TITLE: SPECIAL PERMIT NO. 1930, THOMPSON CREEK COMMUNITY UNIT PLAN, requested by Engineering Design Consultants on behalf of Thompson Creek, L.L.C., for 352 dwelling units, with requests to waive the required lot area for single family dwellings; lot width requirements; multiple family dwellings height requirements; and front, side and rear setbacks, on property generally located east of South 56th Street and Union Hill Road.

P.A.S.: Preliminary Plat #01015 - Thompson Creek **DATE:** January 9, 2002
Special Permit #1930
Use Permit #141
Change of Zone #3338
Change of Zone #3339

THOMPSON CREEK PRELIMINARY PLAT & C.U.P.

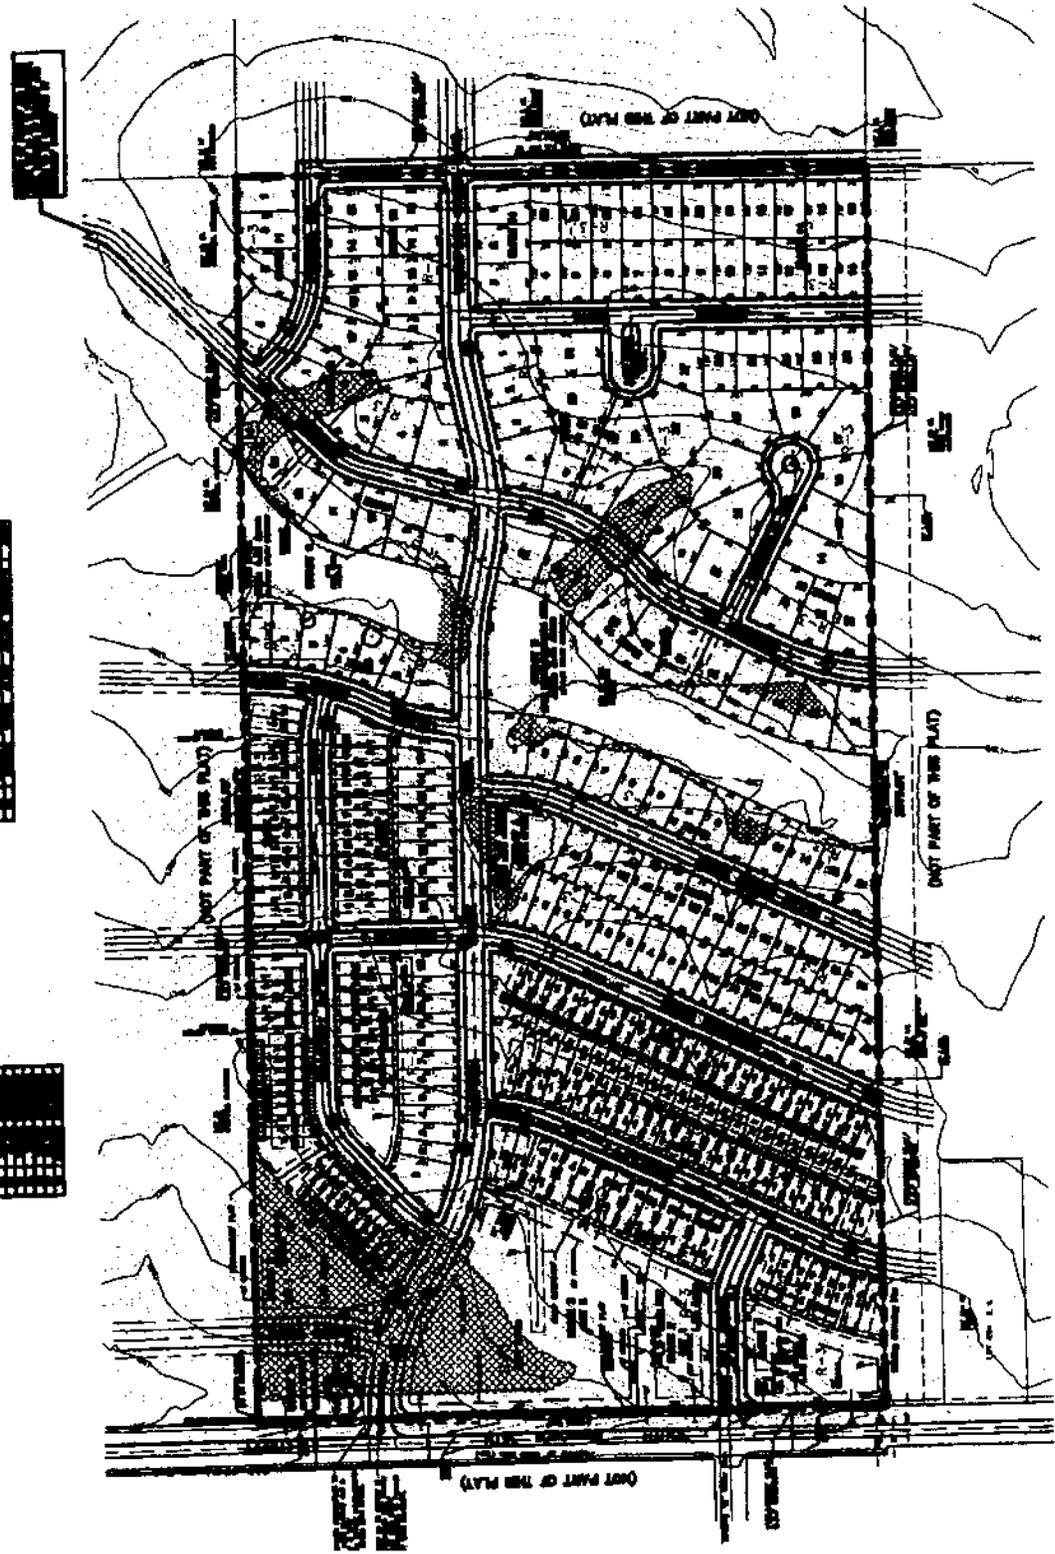
3. The proposed development generally meets the intent of the ordinance.
4. The live/work townhouses on the north side of Billings Drive should be rearranged to face each other rather than lining one side of the street. Outside employees are not permitted in the R-3 zoning district, so the townhouse area should be zoned O-3 and included with the use permit. If the live/work concept is not developed, that area should revert to R-3 zoning and uses. The parking requirement for the office uses can be waived; the residents will use the rear-entry garages and any clients would use the on street parking along Billings Drive. The open space requirement for dwellings in the O-3 district can be satisfied by the close proximity to the mini park and the wooded drainage way between blocks 9 and 21. Some of the requirement could be met through balconies and rooftop space, but the applicant has not provided specific designs for the structures.

5. The residential alleys are too wide. The Subdivision Ordinance requires 20 feet of right-of-way for alleys, but not all of that needs to be paved. The residential alleys in Vavrina Meadows 1st Addition are 16 feet wide, for example.

6. The alley in Block 5 is approximately 900 feet long. There should be a break somewhere near Lots 10, 11, 39 and 40. This will facilitate access to the houses at the center of the block. The corner lots appear wide enough to accommodate 20 feet of north south alley. The cost of constructing the additional alleys can be offset by providing narrower alley widths.

7. Thompson Creek Boulevard is a long, wide fairly straight street which will encourage speeding. The right of way east of Greycliff Drive should be reduced to 60 feet and the pavement width reduced to 27 feet. The width reduction saves the developer the cost for 22,800 square feet of concrete.

10. The proposed sanitary sewer does not meet maximum depth design standards. Public Works & Utilities notes that having downstream property that has not constructed sanitary sewer is not sufficient justification for waiving the design standards. The development of the western portion of this plat should not occur until an outlet sewer is constructed in the natural drainage basin.

11. The lots adjacent to Detention Cell 1 would be flooded by the 100 year ponding elevation. This must be corrected.
12. Bottom treatment of the open ditches is necessary in areas not covered by the permanent pool.

Exhibit "A"

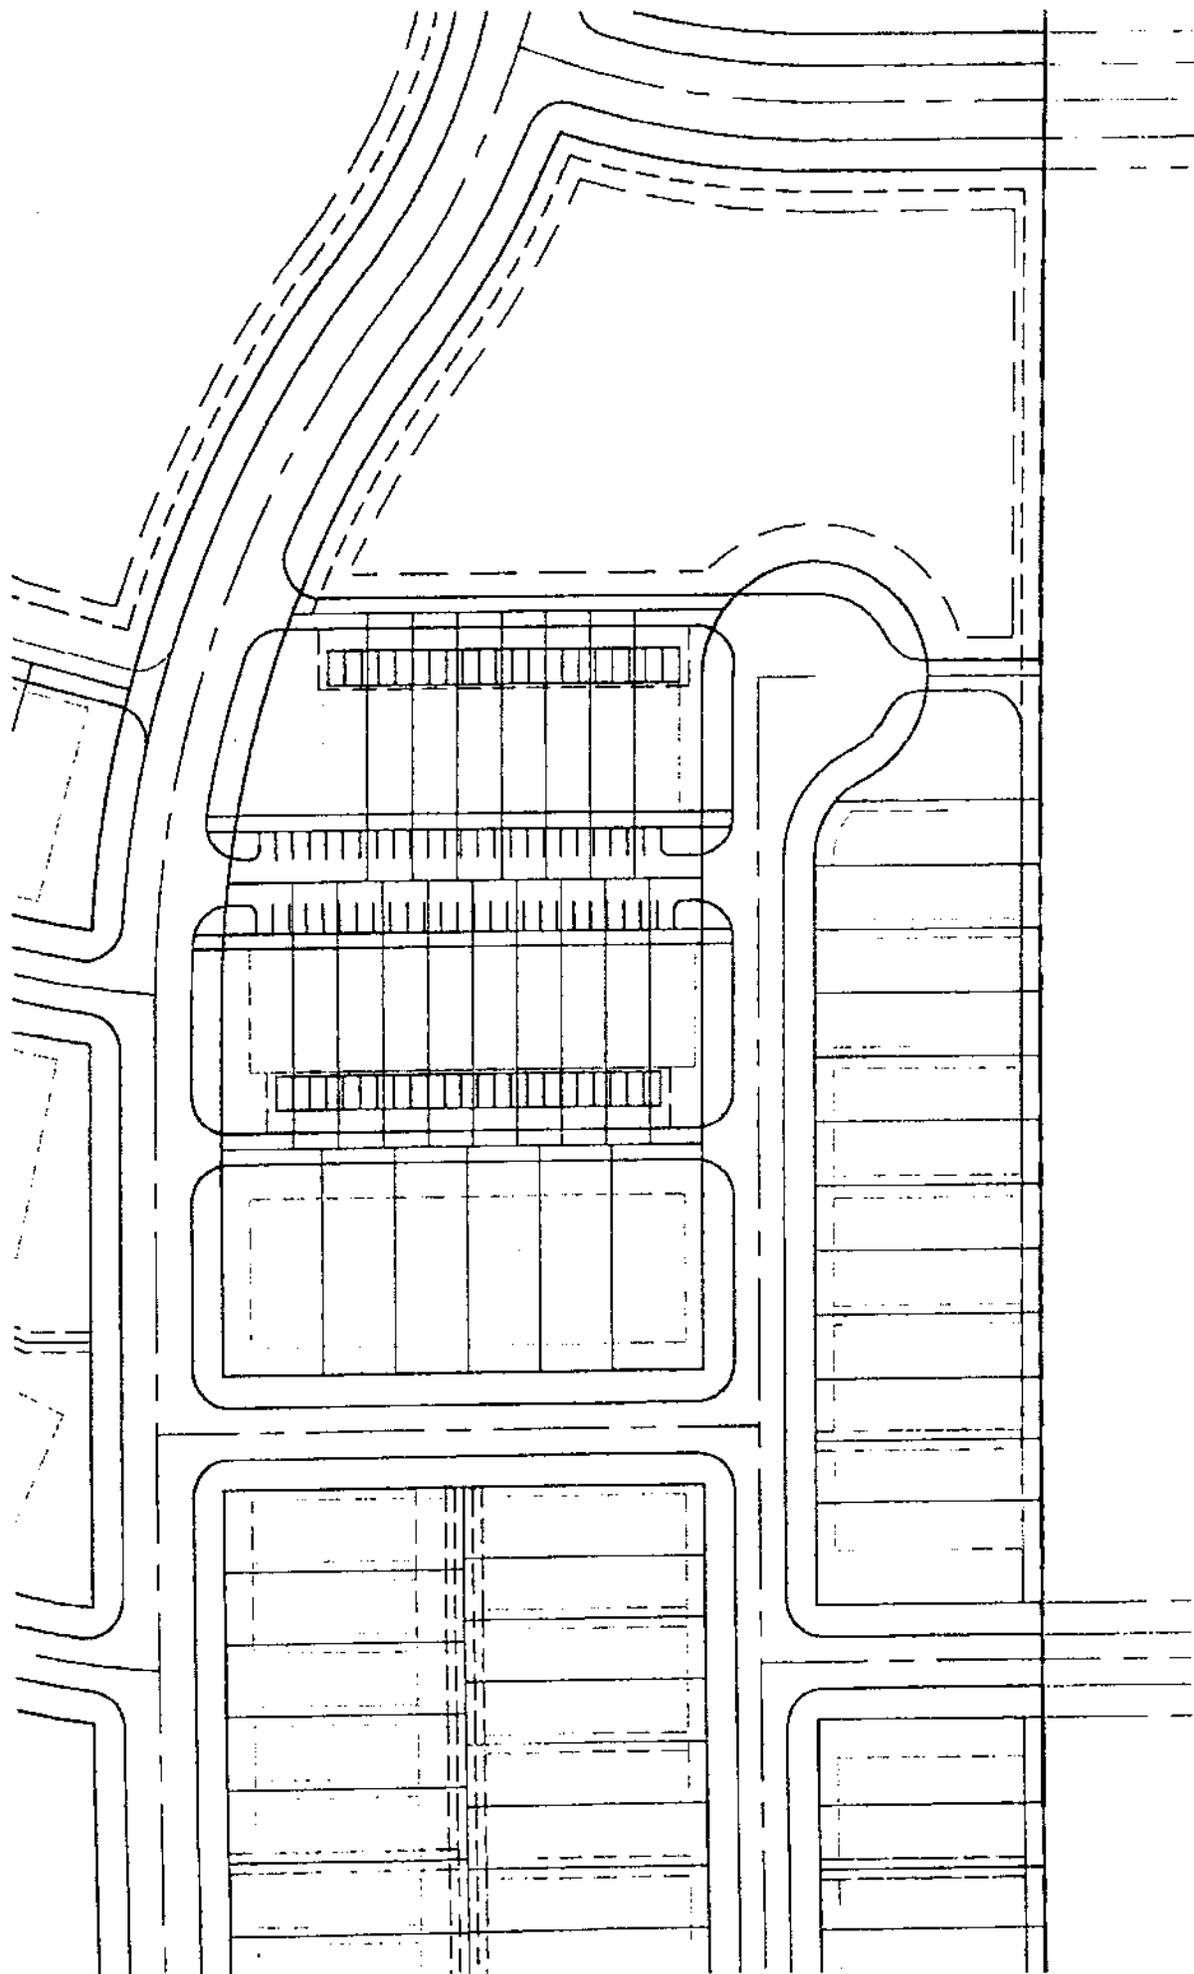
- 1.1.9 Revise the second sentence in Note 38 to read "Signs shall be permitted and located in accordance with the City of Lincoln sign code.
- 1.1.10 Revise the street layout near the live-work units in accordance with Exhibit "A" submitted on 2/20/02, subject to review and approval by city departments. (**As Revised by staff and approved by Planning Commission on 2/20/02**)

Jason Reynolds of Planning staff submitted a revised conceptual layout for the live-work unit area and recommended additional conditions on the use permit and special permit accepting this conceptual layout. The special permit should have a new Condition #1.1.10: "Revise the street layout near the live-work units in accordance with Exhibit "A" submitted on February 20, 2002, subject to review and approval by city departments." The same language should be added as new Condition #1.1.14 on the use permit.
